MANCHESTER TOWNSHIP PLANNING COMMISSION AGENDA WEDNESDAY JULY 29, 2026— 6:00 PM

RVW # 2026-07- 1345 Mill Creek Road- Frederick Fogelman and Teresa Shultz
Fogelman- Final Minor Subdivision Plan

Re: Responses to Comments on the
Final Minor Subdivision Plan
Fredrick Fogelman and Teresa Shultz Fogelman
1345 Mill Creek Road
York, PA 17404
SDC Job #: 1666.1

Re: Fogelman (1345 Millcreek Rd.) Minor Subdivision Plan
Manchester Township Plan #2026-07
Engineer's Project No. 0841.3.16.72

SCALE		AS NOTED
DRAWN BY	JMB	
CHECKED BY	RMH/ARB	
CONTACT	JCP	
DATE	05.04.26	
FILE NAME	1666.1-FSD-1	
JOB NO.	1666.1	
SHEET NO.	FSD-1	REV.
SHT. 1 OF 6	2

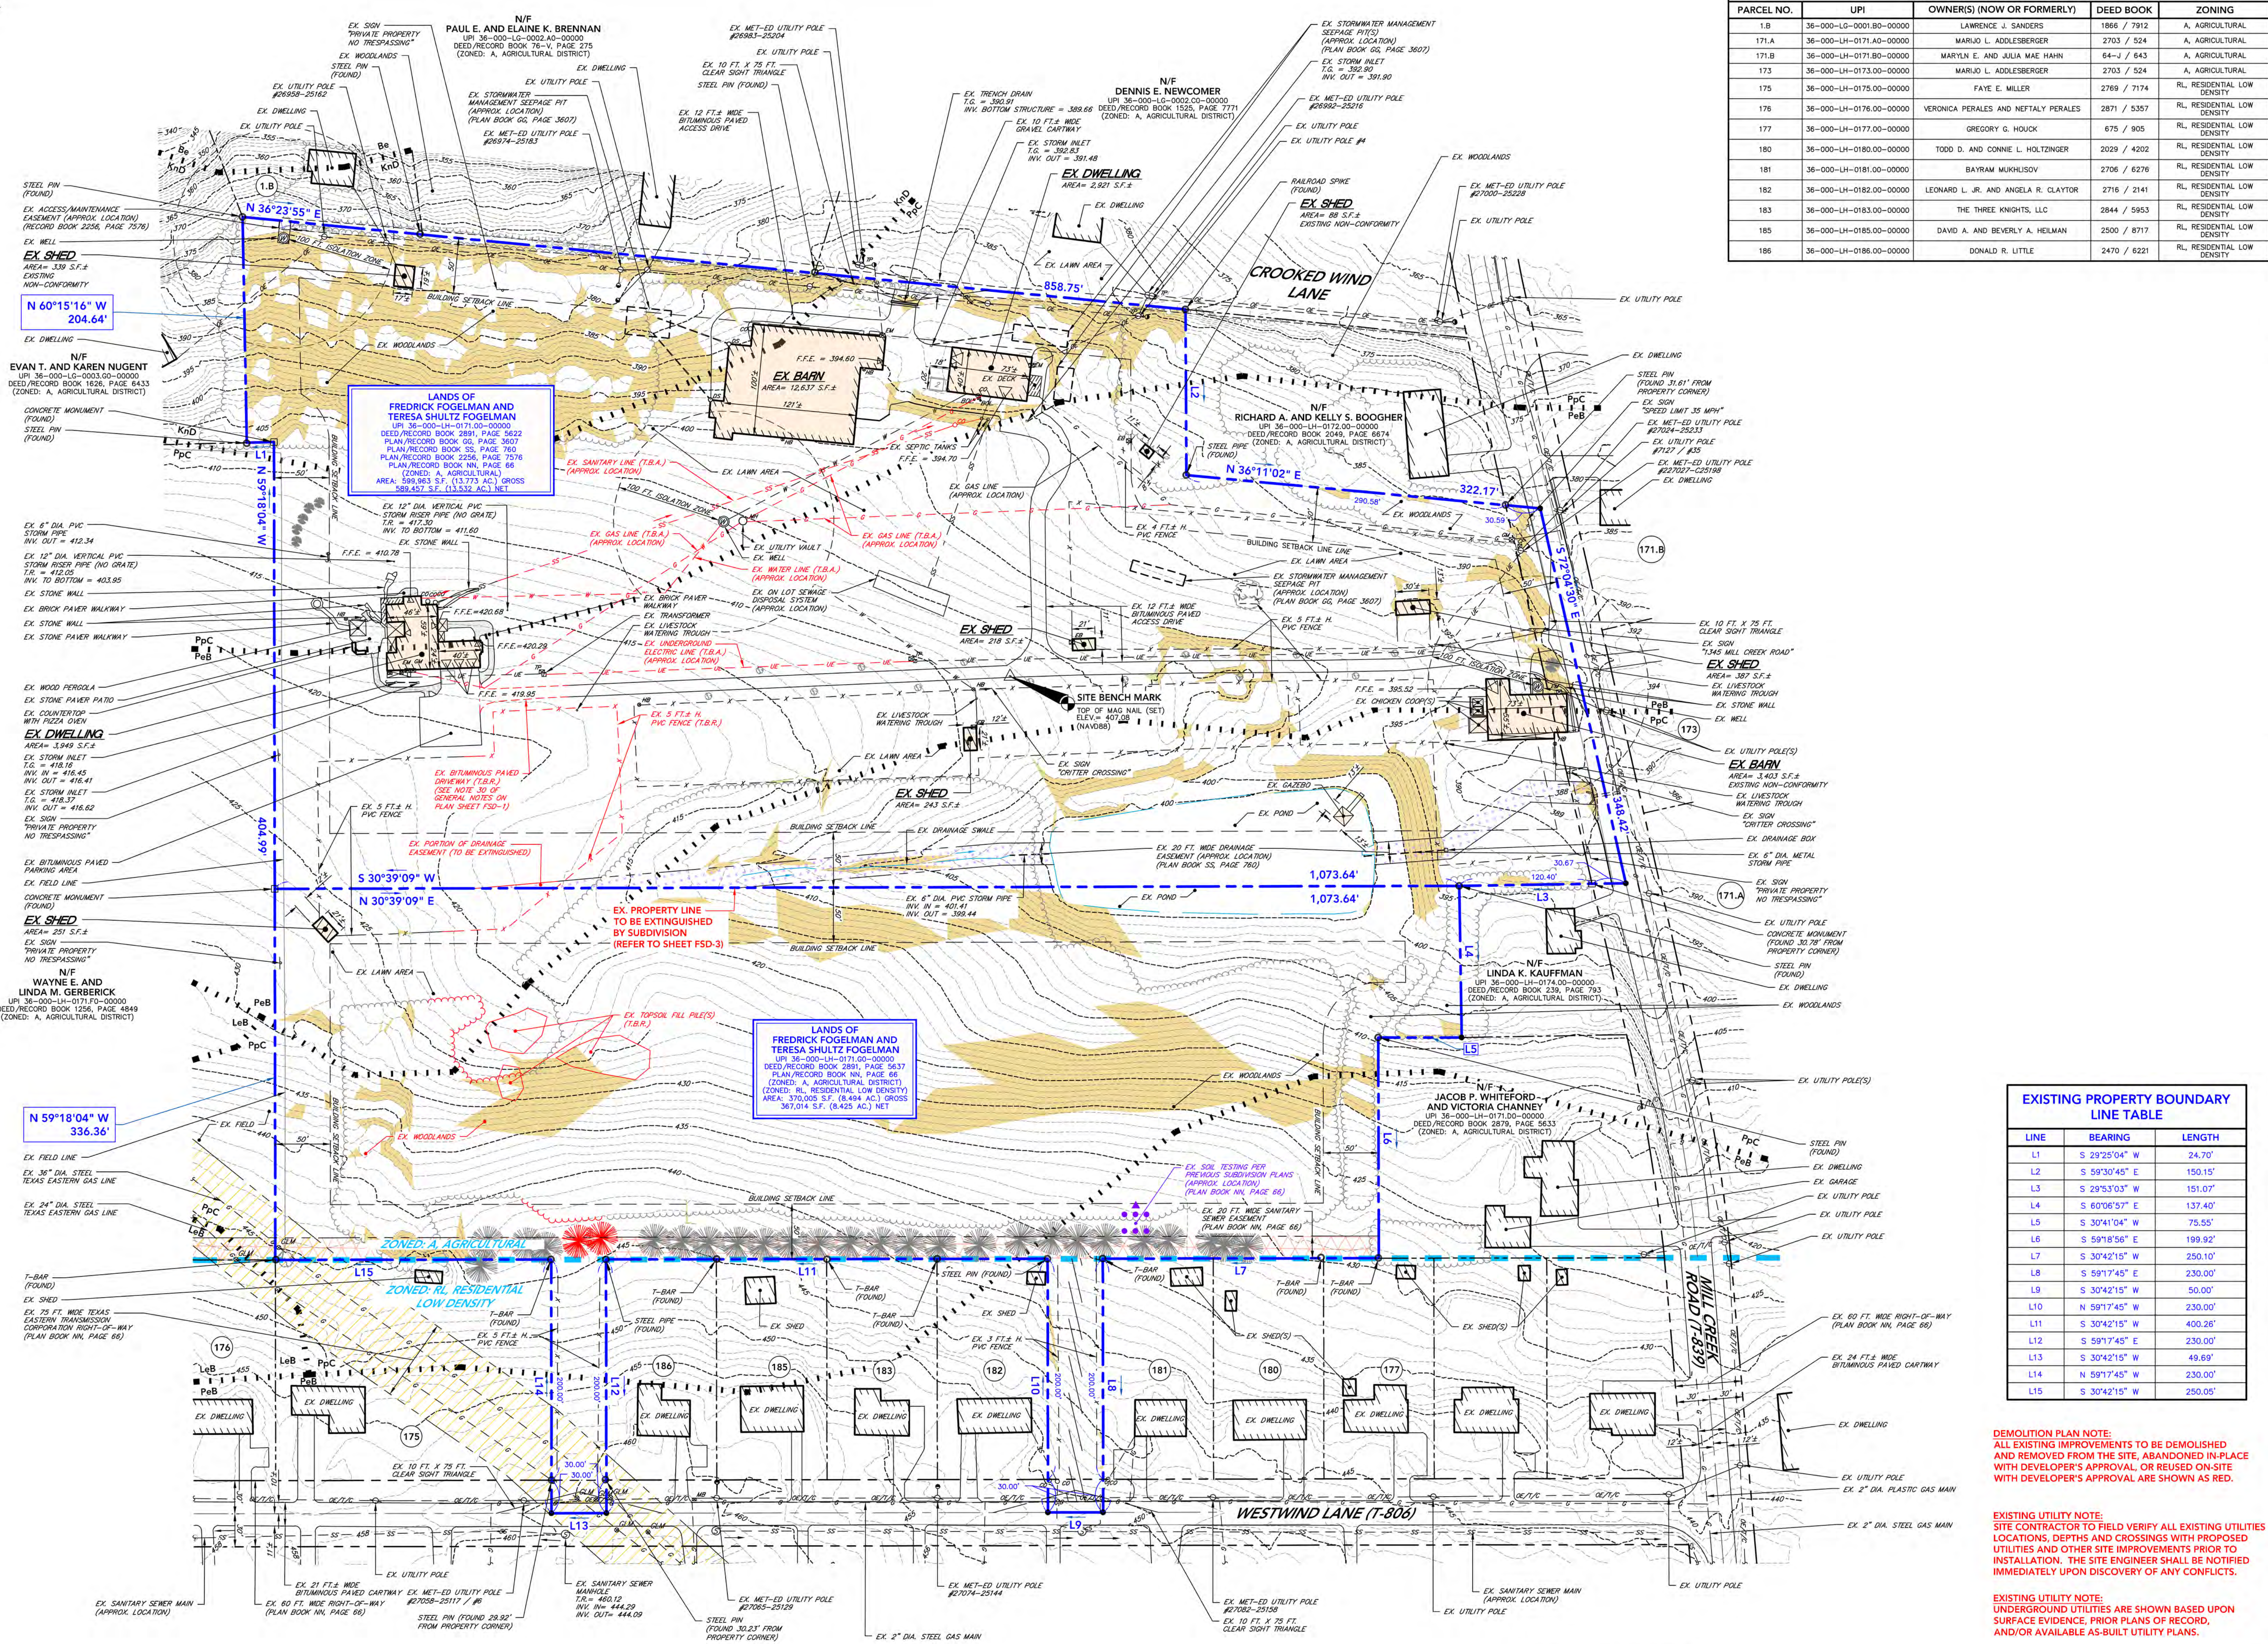
- ~~a. Denote the plan title as "Final Minor Subdivision Plan".~~
 - b. Complete the UPI table prior to recording.
- ~~3. The signature block for review by the Township Engineer shall be revised from "recommended for approval" to "reviewed by". (§22-404.1.5)~~

4. The following shall be listed in the Site Data Table (§22-404.3):
 - a. Any existing or required planning module or planning exemption number(s) issued by PADEP.

- ~~b. List the number of required, existing, and proposed parking spaces for each lot.~~
 - c. The address for each lot shall be identified.
5. The following shall be shown on all relevant plan sheets (§22-404.4)

- b. The UPI Table on Sheet No. FSD-1 has been completed with existing and proposed UPI numbers for the existing and proposed reconfigured lots.
- ~~3. The signature block for review by the township engineer has been revised to state "reviewed by". Refer to Sheet No. FSD-1.~~

4. The following comments have been addressed by:
 - a. Correspondence with DEP and Township SEO is currently on going. Planning module number(s) will be added to the plan when they are received. Refer to note #31 on Plan Sht. FSD-1.

- c. The existing and proposed address for each existing and proposed reconfigured lot have been listed on the UPI table on Sheet No. FSD-1.
5. The corresponding comments have been addressed by:

SCALE		AS NOTED
DRAWN BY		JMB
CHECKED BY		RMH/ARB
CONTACT		JCP
DATE		05.04.26
FILE NAME		
1666.1-FSD-1		
JOB NO.		
1666.1		
SHEET NO.		REV.
FSD-2 SHT. 2 OF 6		2

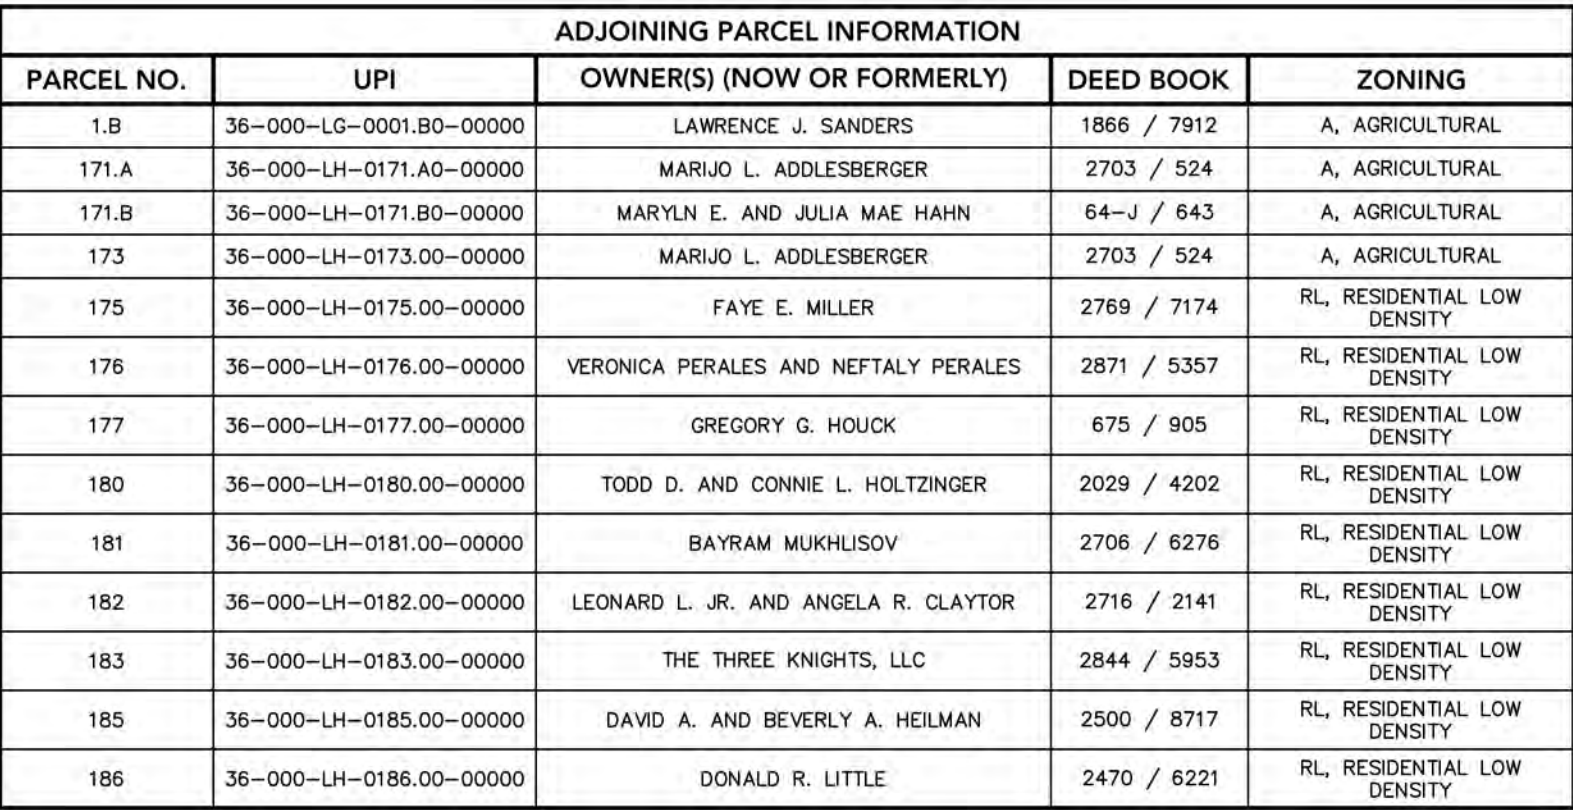
- l. Any existing easements shall be defined and shaded on the plans. **Existing access easement for gravel driveway, labeled as "Crooked Wind Ln."?**

- l. All easements discovered in our deed research have been defined and shaded on the plans. To the best of our knowledge there is no existing access easement for the section of Crooked Wind Lane abutting the site.
